RE: **Addendum No. 1**

Construction Plans, Technical Specifications and Contract Documents
Proposed Industrial Site Perimeter Road - Biewer Sawmill Site Improvements Project
2015 CDBG Economic Development Grant #1132-15-277-ED-01
City of Newton, Mississippi
TEI#16-1106-0012

PLAIN CONCRETE JOINT LAYOUT PLAN
EAST AND WEST ROAD LEGS

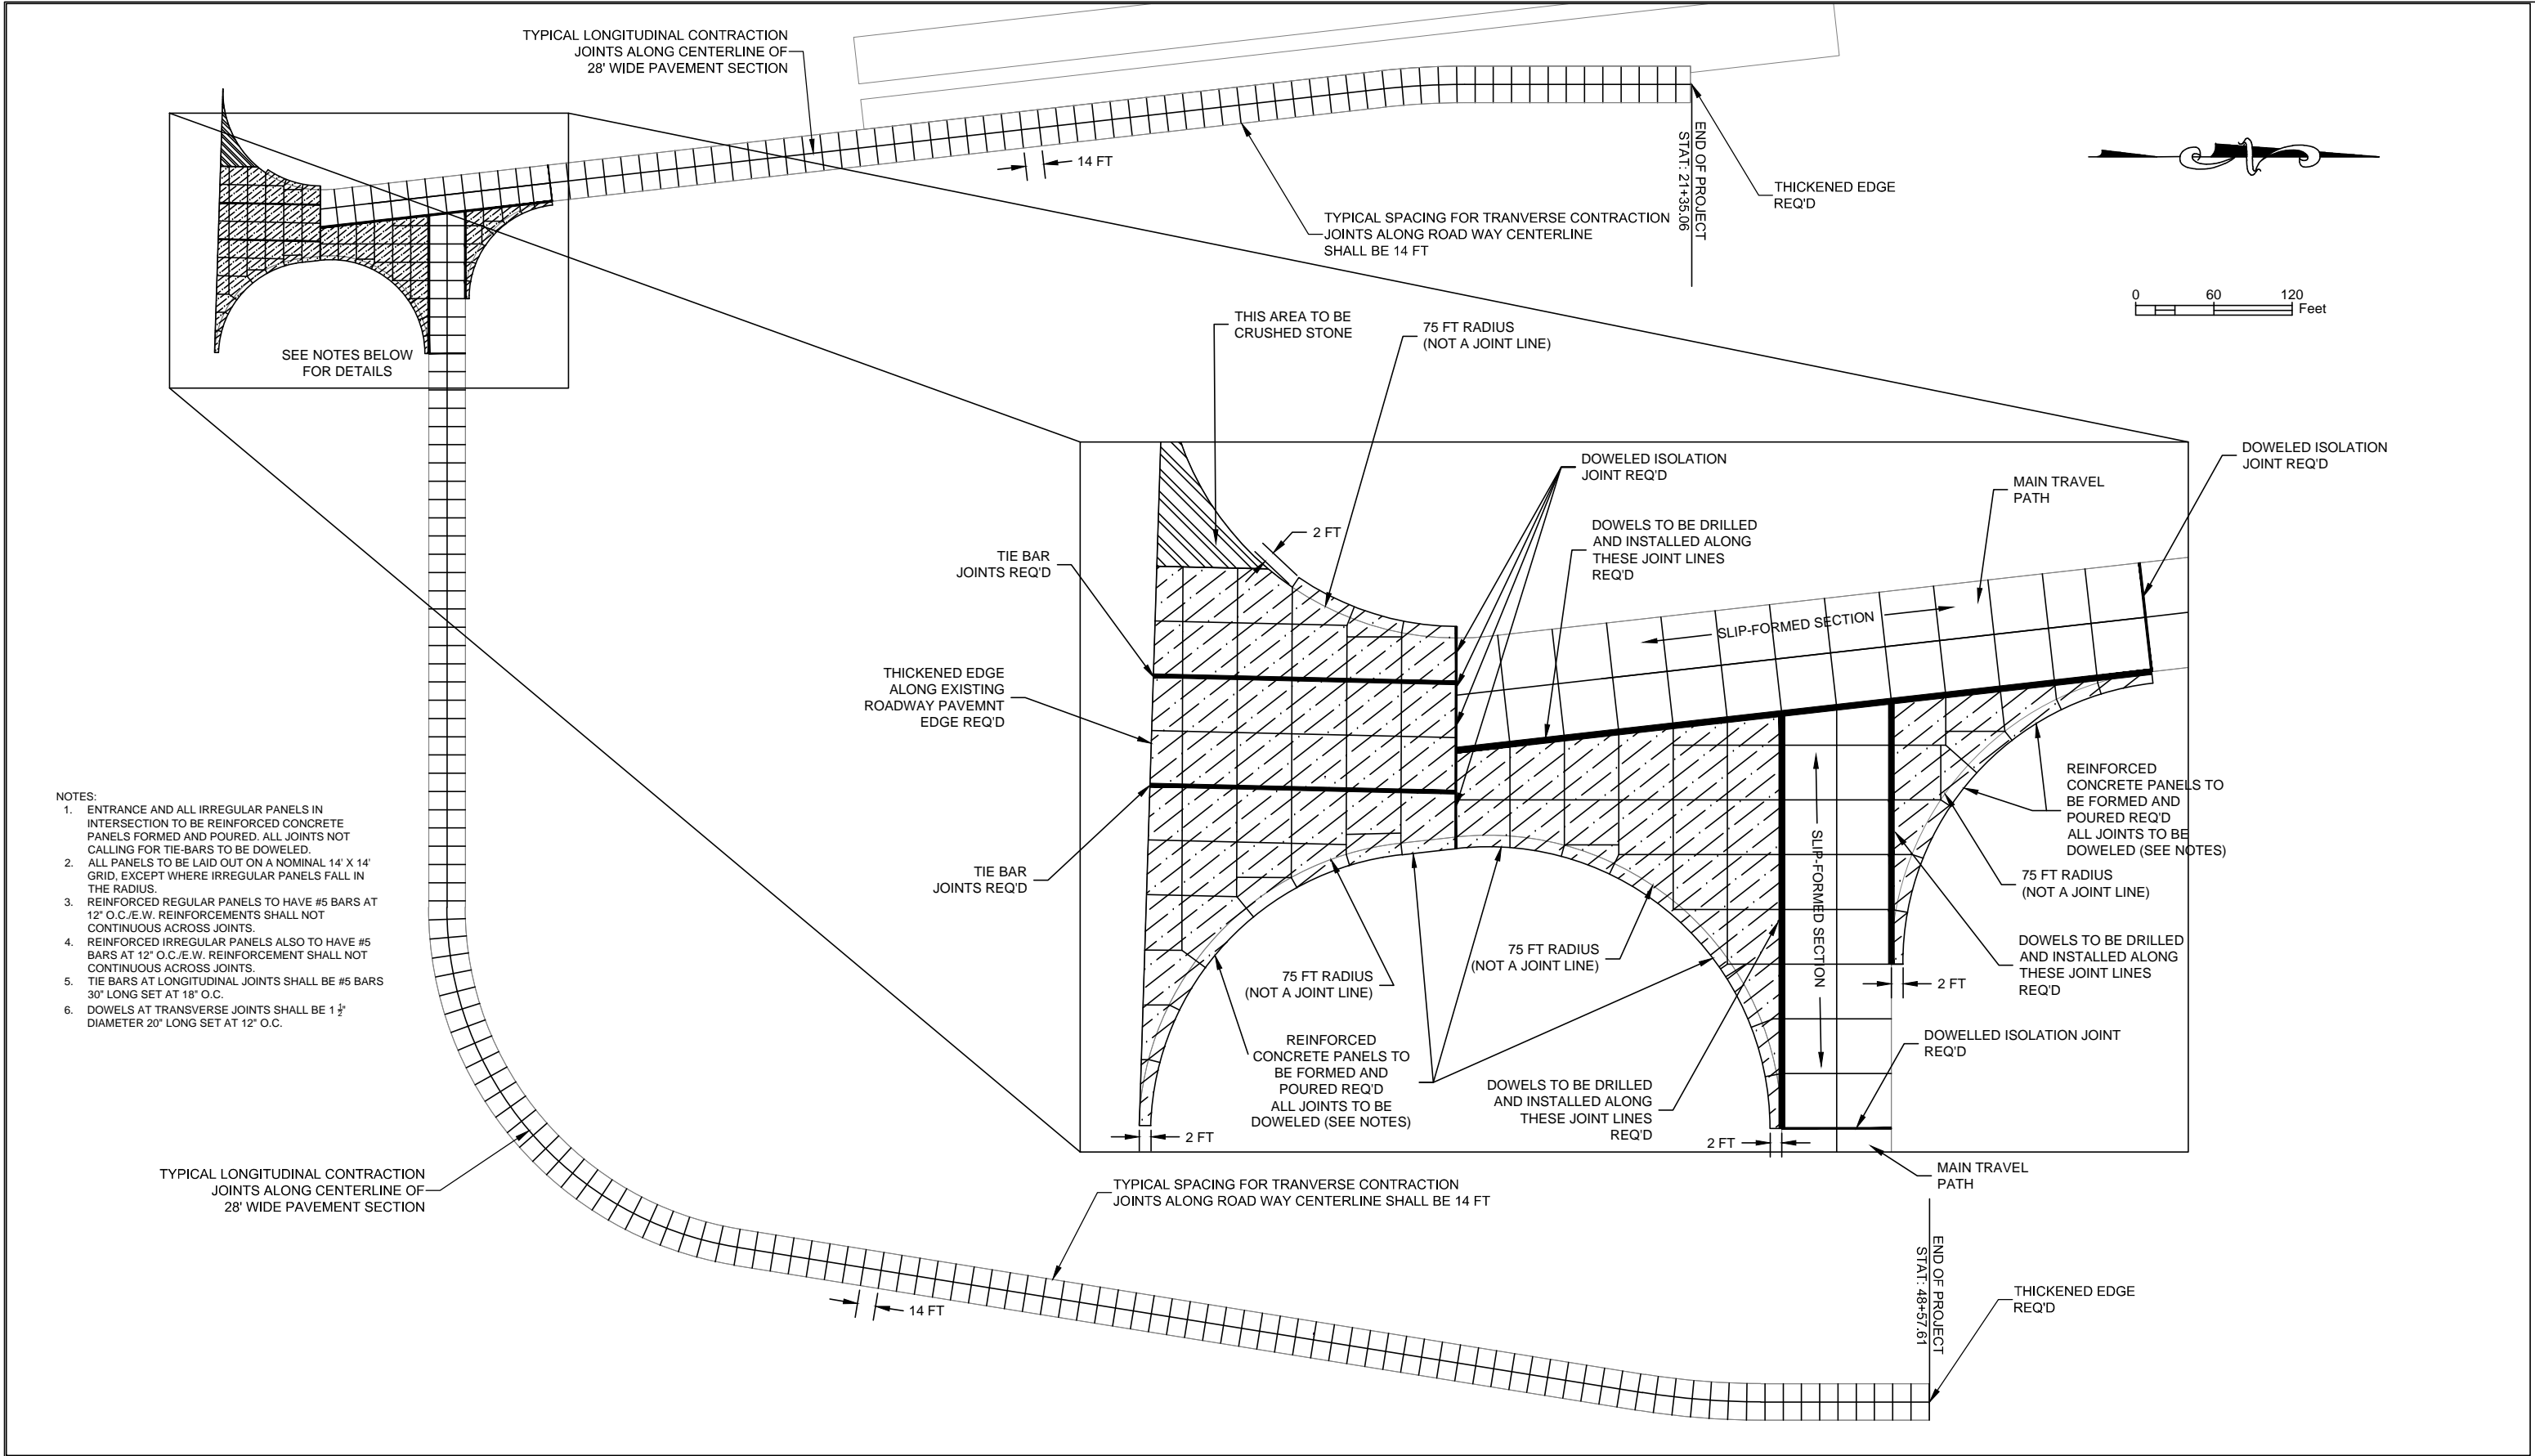
1. Construction Plans: Plan Sheet 20 which provides the Jointed Plain Concrete Pavement (JPCP) joint layout and reinforcing details shall be deleted from the Plan Set for this project, and the revised Plan Sheet 20 which is attached hereto shall be inserted in its place. In addition, a new Plan Sheet 20A which is attached hereto, which provides the Jointed Reinforced Concrete Pavement (JRCP) joint layout and reinforcing details, shall also be added to and inserted into the Plan Set for this project.

REVISION NO. 1	DESCRIPTION REVISED JOINT LAYOUT	DATE 8/3/16	BY: CHW
REVISION NO.	DESCRIPTION	DATE	BY:
REVISION NO.	DESCRIPTION	DATE	BY:
REVISION NO.	DESCRIPTION	DATE	BY:
REVISION NO.	DESCRIPTION	DATE	BY:
REVISION NO.	DESCRIPTION	DATE	BY:

1. The primary longitudinal joint in both the JPCP and JRCP options shall be saw cut in the middle of the 28' wide slip-formed concrete pavement, and shall have 5/8" deformed steel tie bars 30" long installed at 18" (rather than 24") OC. .

2. The primary transverse joints in the JPCP option shall be saw cut on a 14' grid spacing along the centerline of the slip-formed pavement, and shall have 1-1/2" diameter (rather than 1") smooth steel dowels 20" long installed at 12" OC.

6. There shall be no reinforcing in the regular 14' X 14' panels under the JPCP option, but all joints shall have dowels or tie-bars as shown on the joint layout plan.

7. Reinforcing for the irregular panels in the entrance and intersection under the JPCP option shall be #5 bars at 12" OC/EW, and all joints shall have dowels or tie-bars as shown on the joint layout plan. Reinforcing shall not be continuous across the joints.
